REF: 12701  
 U.S. ID. 12701  
 CASE NO. 111  
 -22  
 SUBJECT: A/c 1516 & Noted

REPAIR - TAIL WHEEL RETRACT  
 CABLE GUARD - #13 BULKHEAD

DETAIL

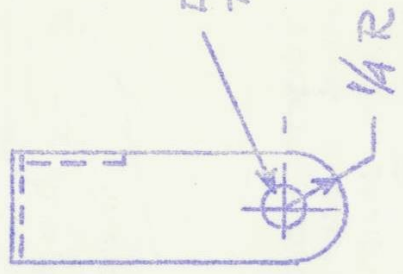
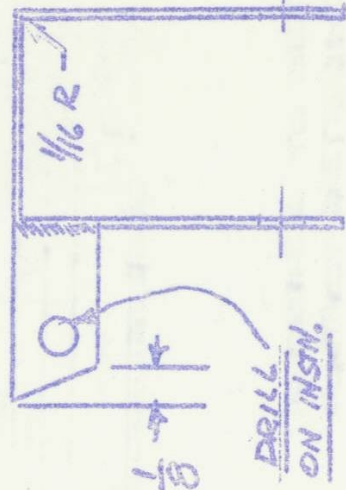
To correct this a bracket will be installed as shown in sketch on page 2 of this EM.

MAKE FROM A130, NORMALIZED  
STEEL. .032 X 1/2 X LENGTH  
NORMALIZE & GRAD. PLATE  
AFTER WELDING

INSTALLATION

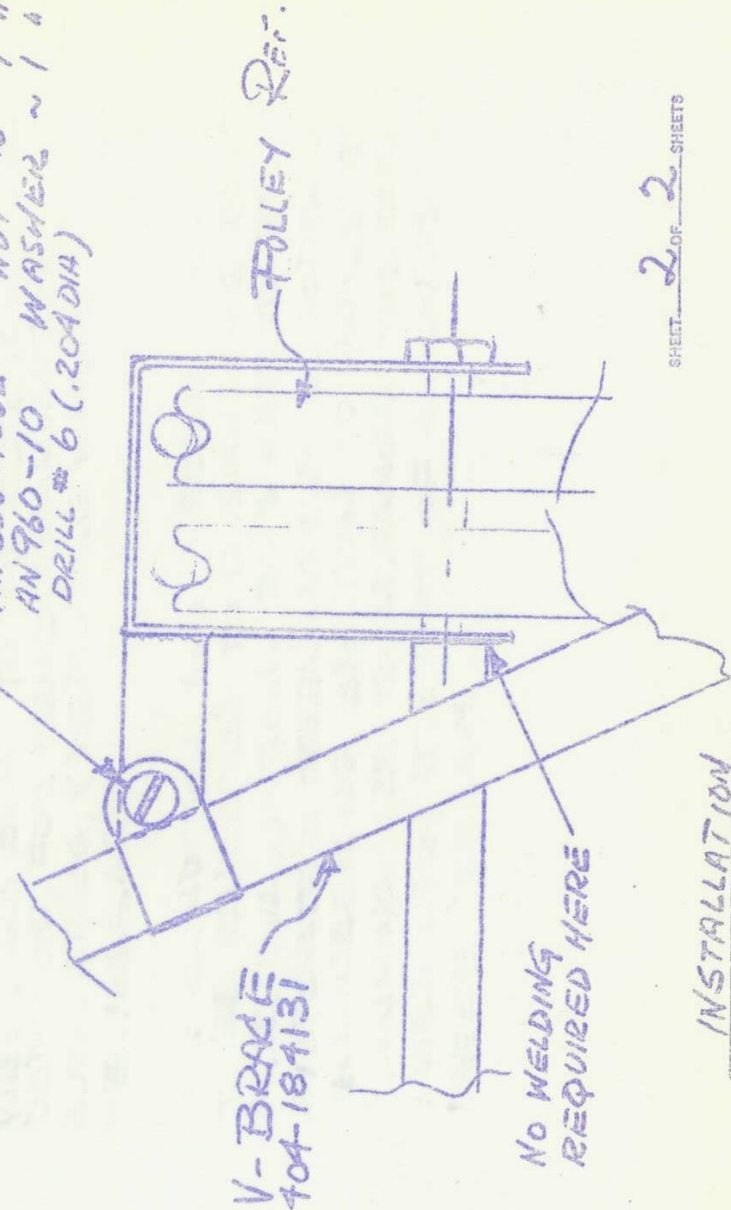
This EM may also be applied to future A/c having this guard missing or unserviceable, but only when the V-brace does not for other reasons require removal. If the V-brace needs to be removed for rectification of other snags, the guard is to be welded on to the pulley attaching bolt support tube in normal manner.

AN 742-8 CLAMP - 1 REQ  
 AN 526-1032-6 SCREW ~ 1 REQ  
 AN 365-1032 NUT ~ 1 "  
 AN 960-10 WASHER ~ 1 "  
 DRILL # 6 (.204 DIA)

NO WELDING  
REQUIRED HERE
